# UNITED STATES PATENT AND TRADEMARK OFFICE

| APPLICATION NO. | FILING DATE | FIRST NAMED INVENTOR | ATTORNEY DOCKET NO. | CONFIRMATION NO. |
|-----------------|-------------|----------------------|---------------------|------------------|
| 10/773,399      | 02/09/2004  | Kuo-Tai Su           | MR3287-12           | 6605             |

## Office Action Summary

## **DETAILED ACTION**

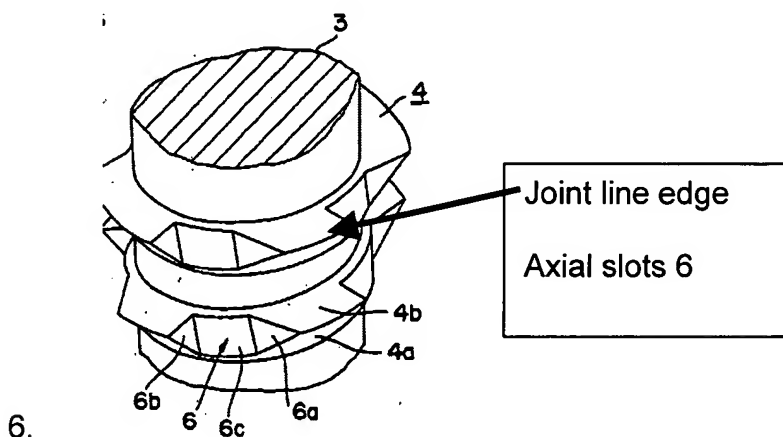
5. Claim 1 is rejected under 35 U.S.C. 102(b) as anticipated by Hiroyuki USP 5110245,

Hiroyuki Fig 2 (above) teaches a thread forming screw comprising a head (2)

with an extending shank (3) and a helically formed thread (4) wherein the thread consists of an upper flank (4b), a lower flank (4a) and an edge on the joint line of the upper and lower flanks (See Fig 2 above) and an even number of axial slots (6) formed in the thread (as best understood, Fig 3 shows an even number, four, axial slots), each axial slot beveled with a back angle (formed by surface 6a, which forms an angle sloping back relative to the joint line edge) to form a tilt surface (6a is the surface, tilted

relative to either the upper or lower flank), so as to form a cutting edge from which the low flank and tilt surface extend (see also col 4 lines 3-21 – surface 6a is leading and thus inherently the edge between 6a and the low flank will be a cutting edge.
